Load Shared Peer PBBN Interfaces

Version 1

Stephen Haddock
March 17, 2008
802.1 Plenary, Orlando

Load Shared Peer PBBN

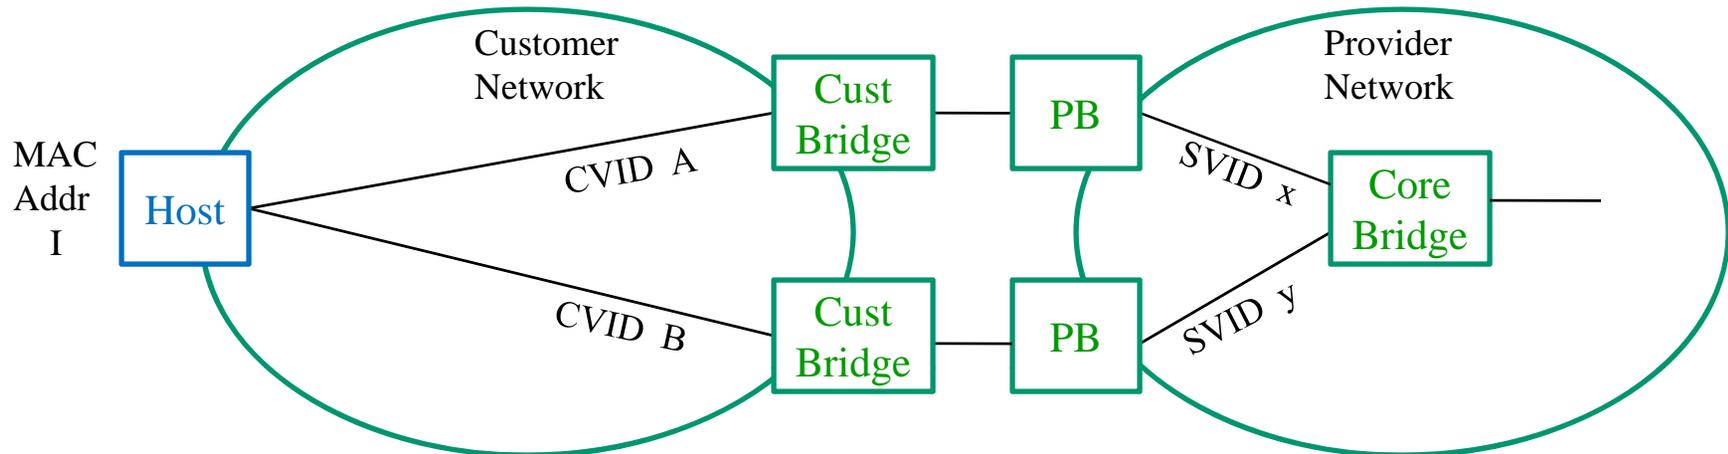
1. Frames originating at PIP with MAC address and ISID 1 will arrive at the Core Bridge in PBBN-E with B-SA=I and BVID=x.
2. Frames originating at PIP with MAC address I and ISID 2 will arrive at the Core Bridge in PBBN-E with B-SA=I and BVID=y.
3. If $x=y$ (meaning ISID 1 and ISID 2 go on the same B-VLAN in PBBN-E) then the Core Bridge will see frames with the same B-SA and the same BVID arriving on two different ports. This will cause the Learning Process to thrash, and will likely result in loss of frames destined for I.

De Heer comment #24 on 802.1ah-d4.1 raises this issue.

- In 802.1ad we decided this was not an issue to be resolved by any change to the standard.
 - The problem can be avoided by assuring either that frames from a single Host cannot be injected into the Provider Network at more than one point, or that they are assigned to different S-VLANs at those points.
 - There is nothing actually in the standard that addresses this.
- Likewise the comment (de Heer comment #24 on 802.1ah-d4.1) does not propose any technical change to the standard to address this issue.
 - The problem can be avoided by assuring either that frames from a single PIP cannot be injected into a Peer PBBN at more than one point, or that they are assigned to different B-VLANs at those points.
 - Do we need a note to this effect in 26.6.2 (as suggested by the commenter's proposed resolution)?
